DEVELOPMENT SERVICES

PLAN REVIEW CONDITIONS

February 25, 2022

Permit No: PRCOM20220590
Project Title: MO' BETTAHS
Project Address: 520 NW CHIPMAN RD, LEES SUMMIT, MO 64086
Parcel Number: 241167
Location / Legal Description: SUMMIT ORCHARD LOT 4C-1 4C-2 AND 4C-3 CORRECTED SUMMIT ORCHARD LOTS 4A-4E --- LOT 4C-2
Type of Work: NEW COMMERCIAL
Occupancy Group: ASSEMBLY FOR FOOD AND DRINK INC BARS, RESTAURANTS, BANQUET HALLS
Description: NEW RESTAURANT WITH DRIVE-THRU

A112

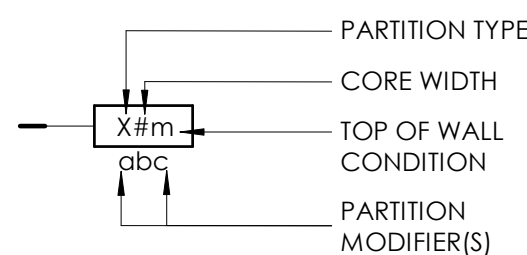
4. 2018 IMC 507.2.6 Clearances for Type I hood. A Type I hood shall be installed with a clearance to combustibles of not less than 18".

Action required: Walls adjacent to and within 18" of Type I hood must be non-combustible. (Including exterior wall at side of hood) Modify design to comply.

Response: See updated sheet A112 with Gyp bd. added to walls as non-combustible material within 18" of both hoods.

PL103

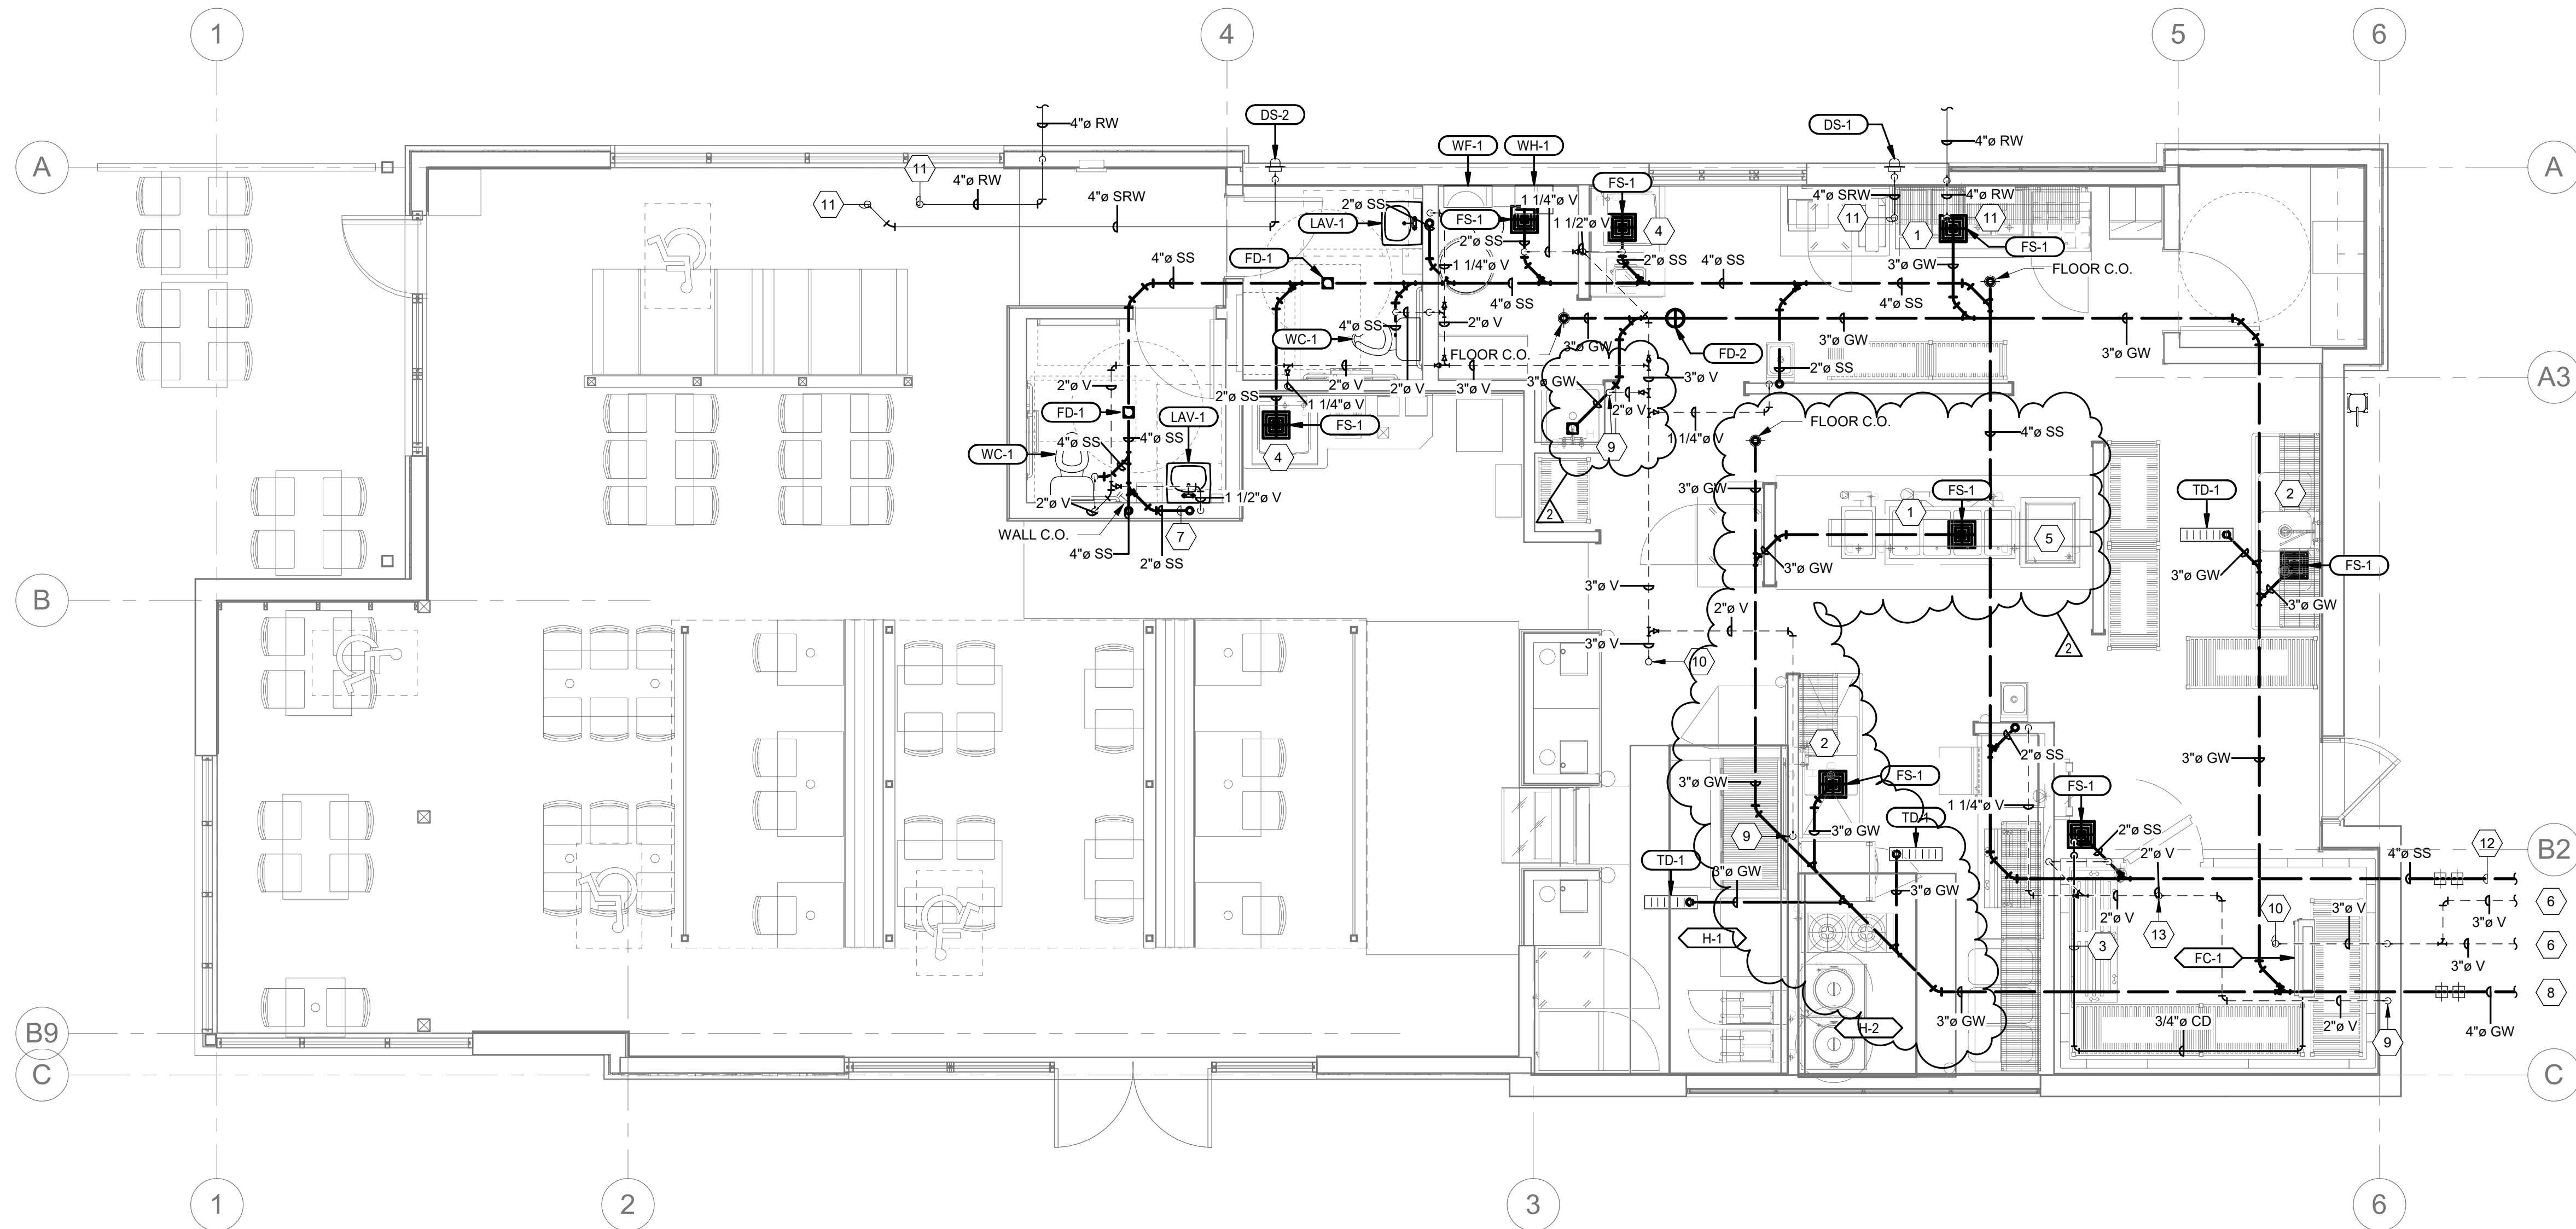
6. Grease interceptor design not found.

Action required: Provide complete design for grease interceptor. (location shown on civil plans but refers to this architectural set for design)

Response: Grease Interceptor called on sheet C6.3. Following revisions made to plumbing sheets.

PE601 – removed previous grease interceptor sizing requirements as they were for a gravity grease interceptor. Moved sizing requirements to sheet PL103 (for a hydro-mechanical grease interceptor as will be installed).

PL103 – Added sizing requirements for hydro-mechanical grease interceptor. Revised associated keynote for grease waste line to space (G.I. shown on civil plans).

ES101

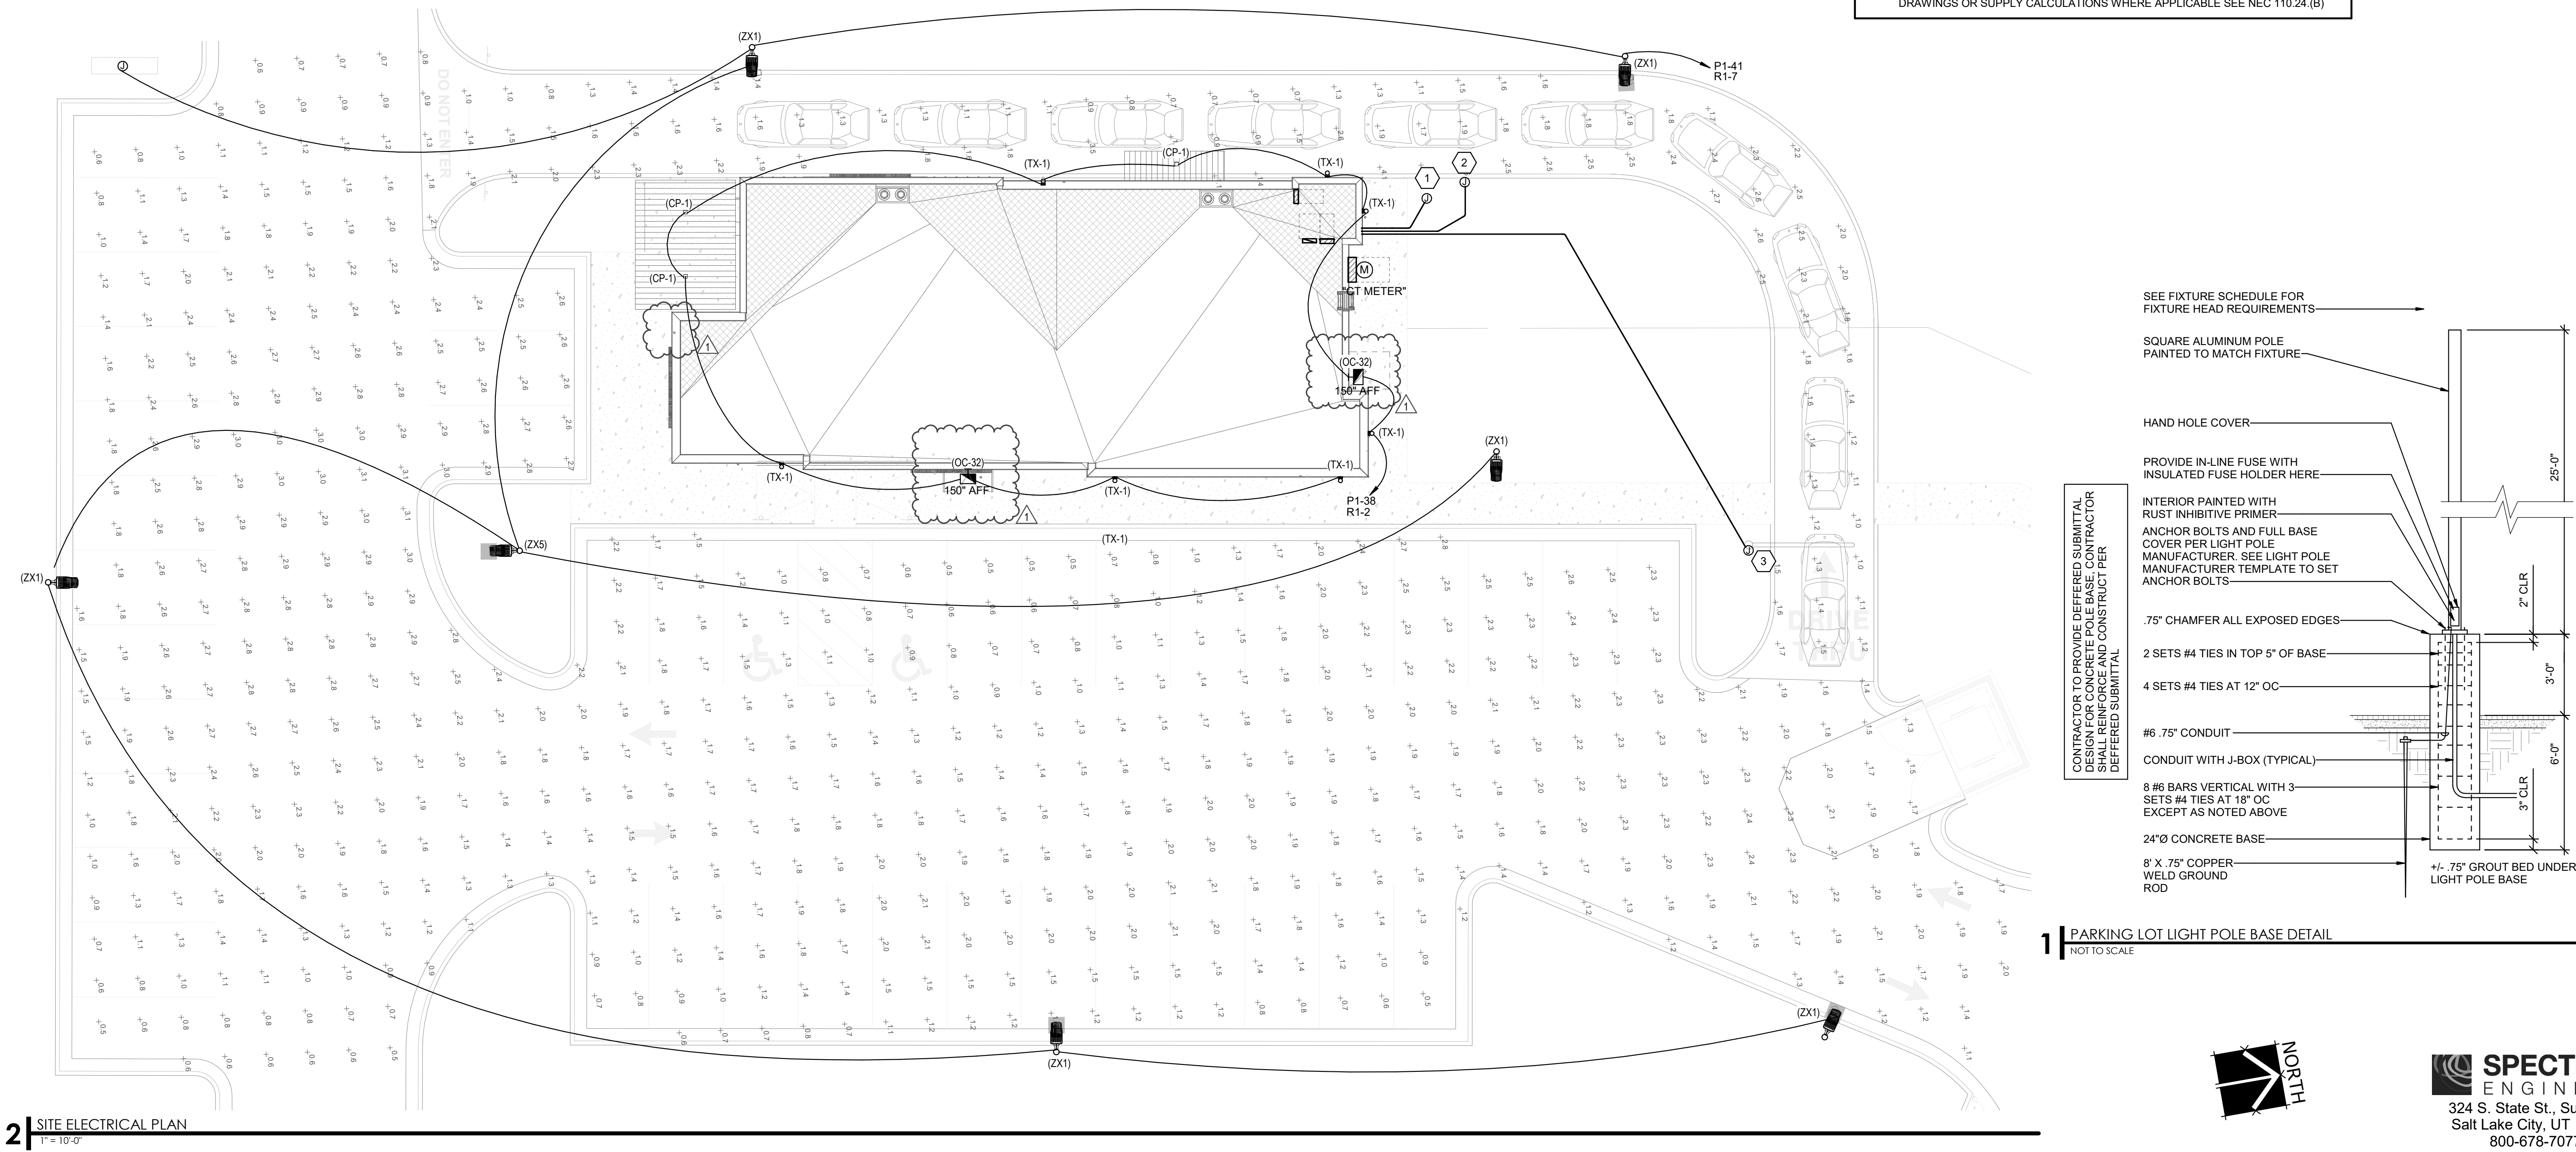
2. 2018 IFC 1008.3.1 & 3.2 Emergency power for illumination.

(Provide External illumination at all exits)

Response: See updated sheet ES101 with exterior emergency lighting fixtures added to both exits. Specified option has been added to lighting fixture schedule EL601.

EP102

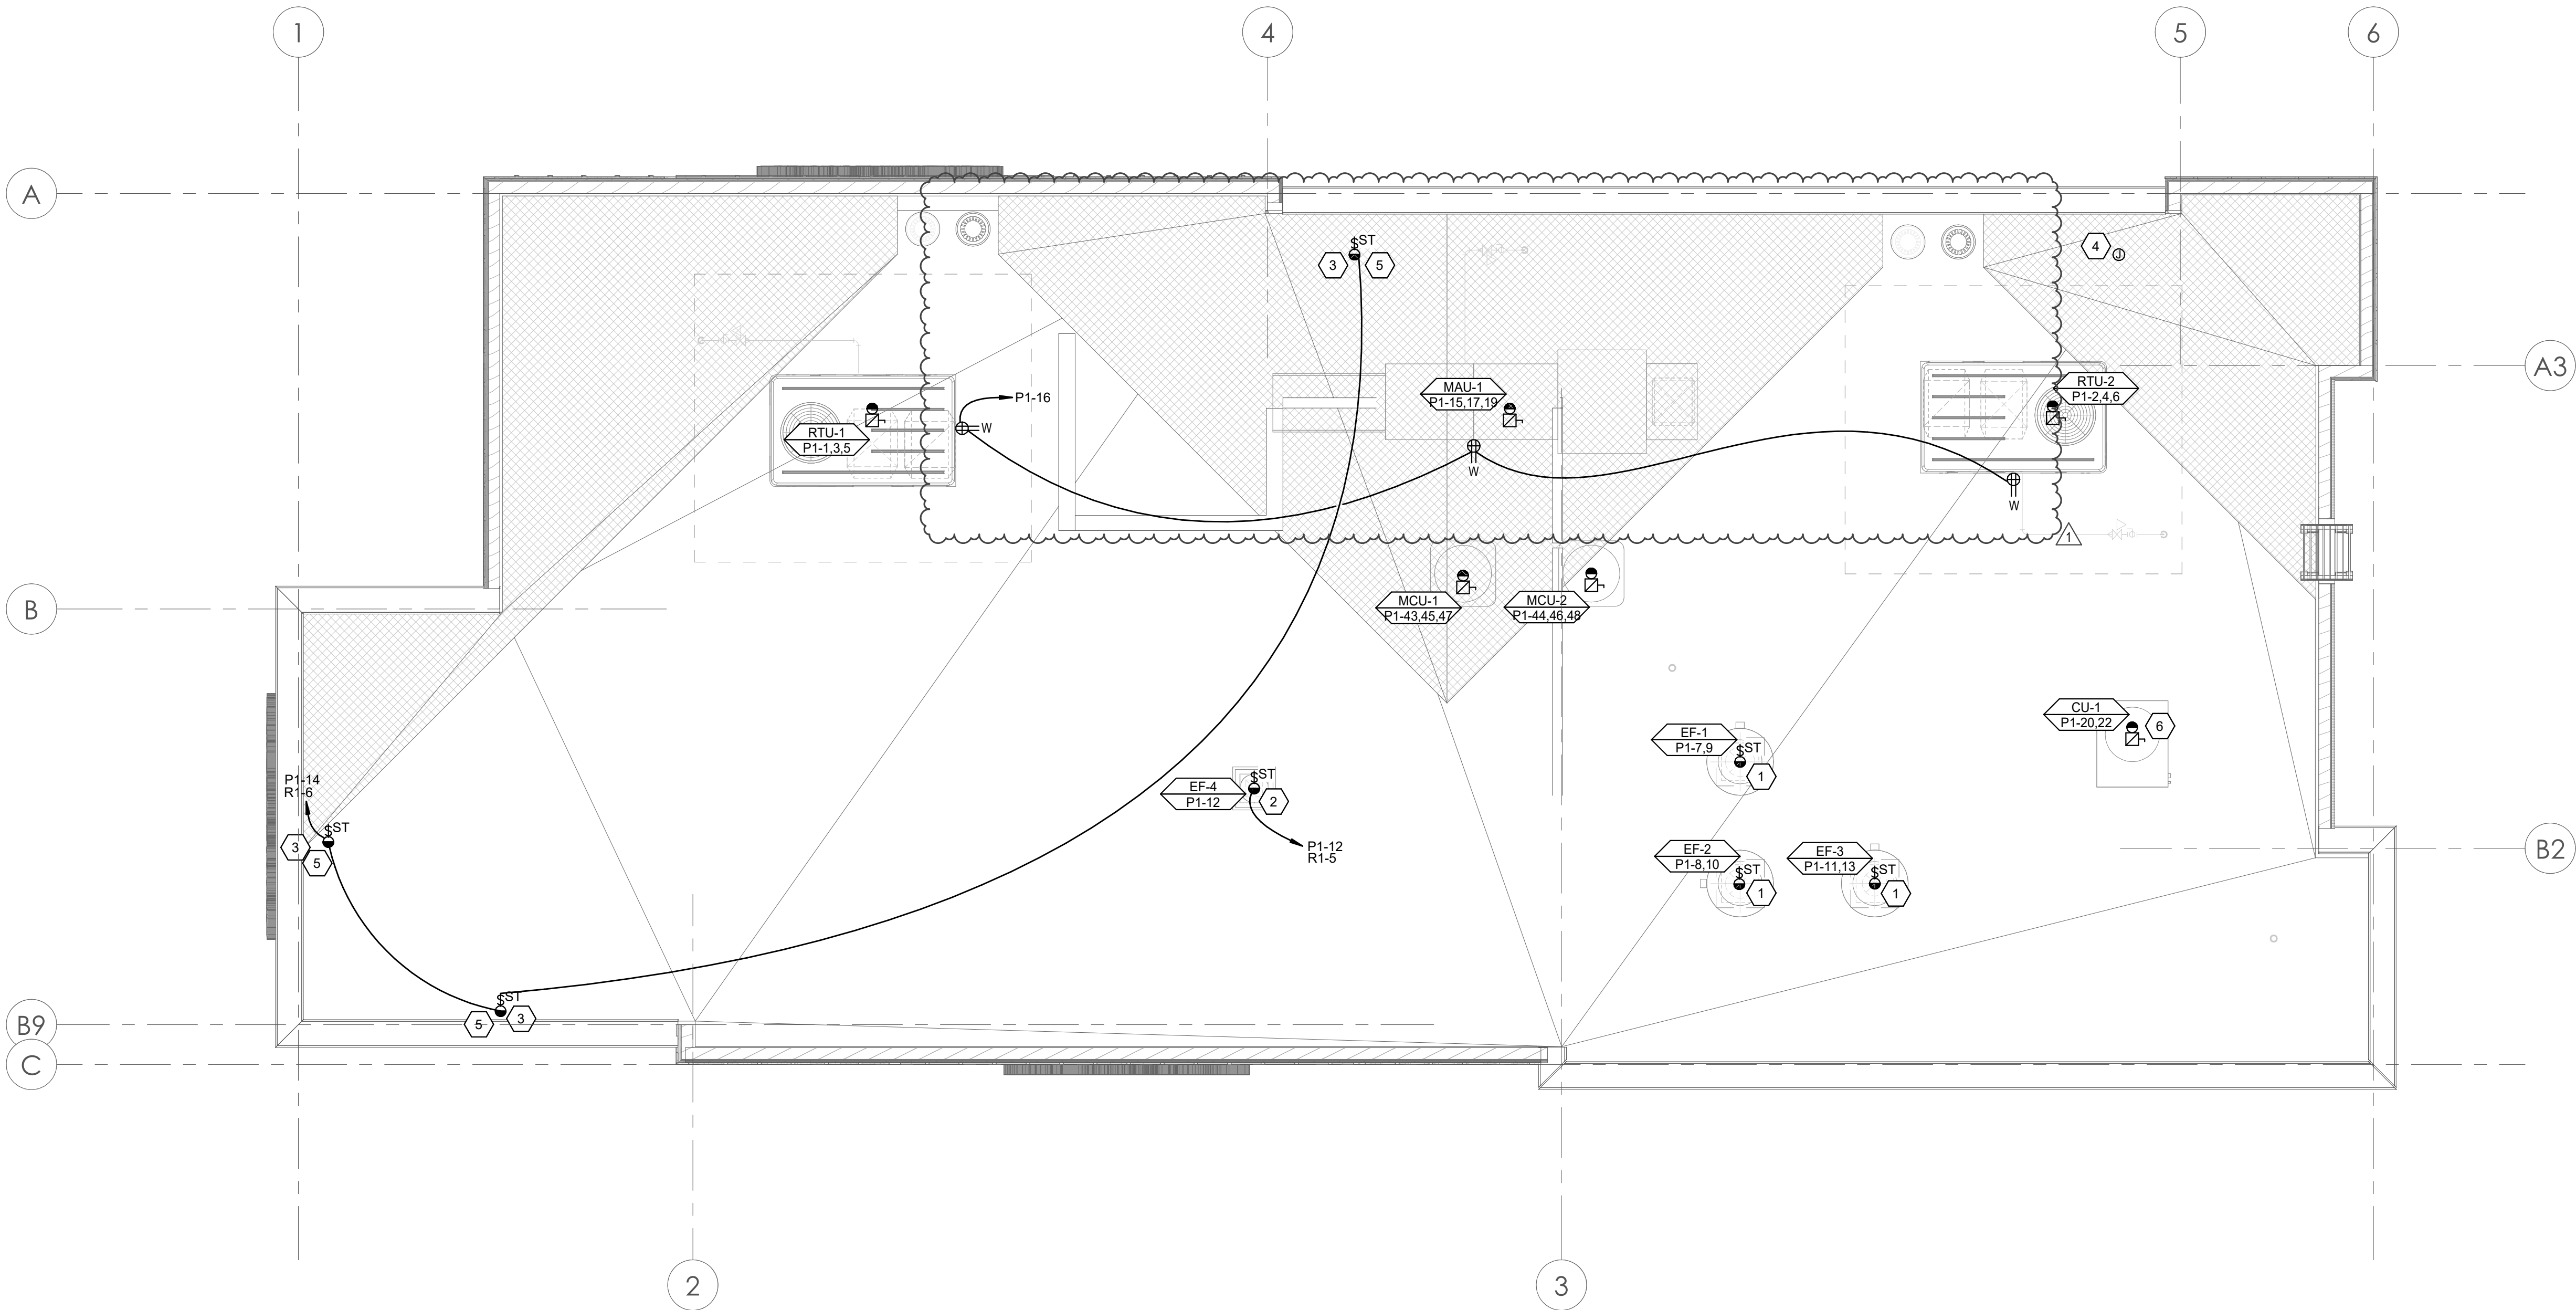
7. 2017 NEC Article 210.63 Heating, Air-Conditioning, and Refrigeration Equipment Outlet. A 125-volt, single-phase, 15- or 20-ampere-rated receptacle outlet shall be installed at an accessible location for the servicing of heating, air-conditioning, and refrigeration equipment. The receptacle shall be located on the same level and within 25 feet of the heating, air-conditioning, and refrigeration equipment. The receptacle outlet shall not be connected to the load side of the equipment disconnecting means.

Action required: Provide additional receptacle(s) on roof so all equipment is within 25' of connection.

Response: See updated EP102 showing revised locations of receptacles.
